UNITED STATES PATENT AND TRADEMARK OFFICE

Office Action Summary

10/055,757

BARANSKI, RICH

Figure 1'

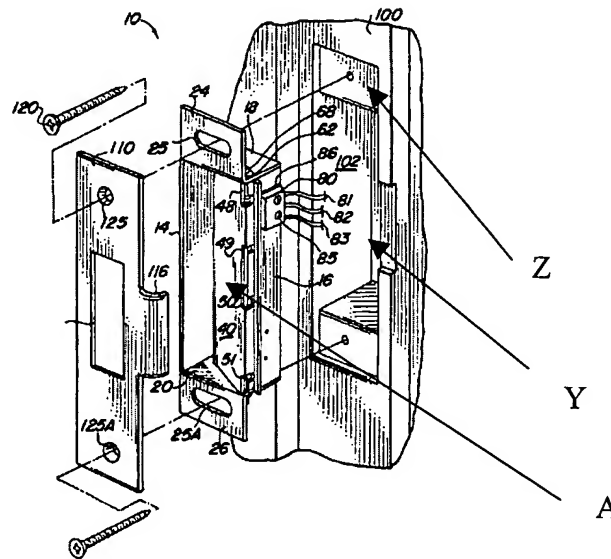
4. Claims 19-20 are rejected under 35 U.S.C. 102(b) as being anticipated by Roth (U.S. Patent No. 5,757,269). Roth discloses an adjustable door guide latch slot assembly as claimed; wherein said assembly includes a striker plate (110) having a latch opening (112) therein; a door guide having an outer surface (Z) and an inner surface (Y) with a recessed area larger than said striker plate and having an opening therein extending from the inner surface to the outer surface with said opening being larger than said striker plate latch opening; and a security device (12) having a latch receiving port (A), the security device extending out from the outer surface of the door guide, whereby said striker plate maybe placed flat against said door guide inner surface within said recessed area and maybe adjustably affixed to said door guide inner surface so that said striker plate latch opening aligns with said slidable door latch and whereby said security device is affixed to said adjustable striker plate so that said latch receiving port aligns with both said striker plate latch opening and said slidable door latch. As it concerns claim 20, as shown in

Figs. 3A & 3B, the depth of said recessed area is at least as great as the thickness of said striker plate, see Fig. 1'.
